## O-ring tear when installing SMART-O in oil pans with heli-coil inserts

## Installing 'F1' plug in oil pans that use a helicoil insert may tear O-ring

SMART-O Part # F-1

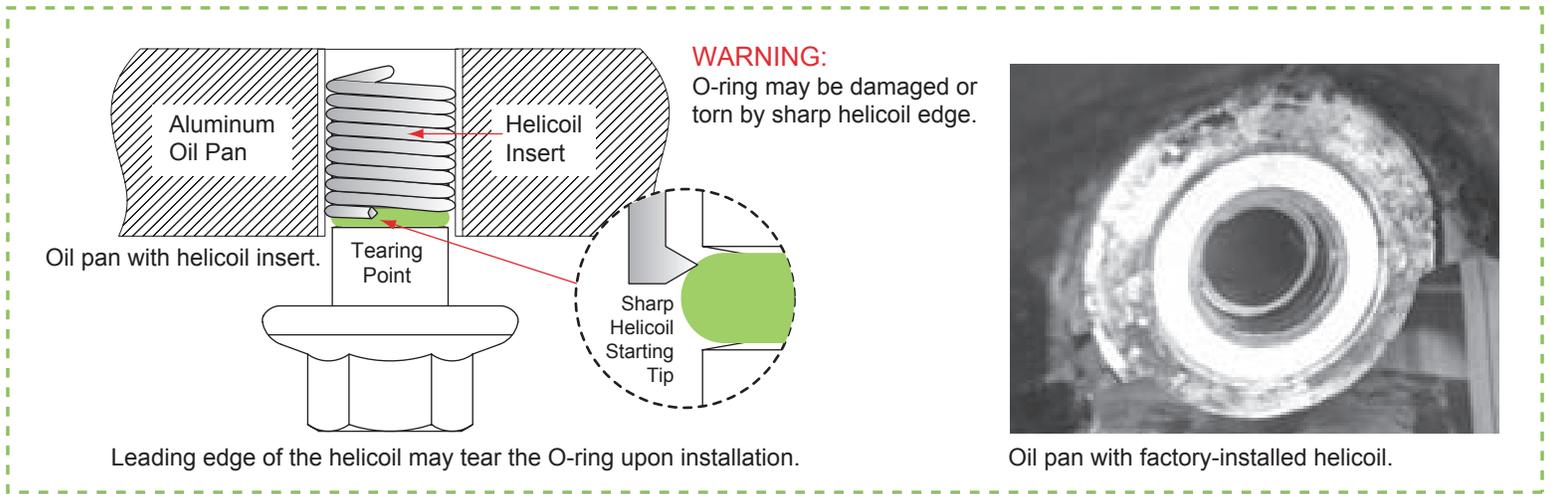
The affected vehicles will have an aluminum oil pan with a helicoil installed from the factory.

- Affected vehicles: Chevrolet, GMC, and Cadillac Trucks and SUV's
- Affected years: 2000 - 2007
- Affected engines: 4.8L, 5.1L, 5.3L, and 6.0L V8 engines
- VIN codes: U, V, and T

Not all vehicles will have this issue, it is therefore important to inspect each vehicle within the above years, makes, and VIN ranges first.

1. Carefully check the drain plug port of the oil pan and inspect if it has a helicoil insert. Initial testing is completed but will be part of a continuous process.
2. DO NOT INSTALL AN F-1 SMART-O PLUG, IF A HELICOIL IS PRESENT
3. Instead, inspect the OEM washer, then reinstall the OEM plug and torque to manufacturers' specifications

Install 'H1' SMART-O plug - an alternative for helicoil-insert oil pans.

The H1 plug is soon to be released. Testing is completed but will be part of a continuous process. It has been verified that the H1 plug can be installed repeatedly without damage to the O-ring, although heli-coil thread conditions may vary.
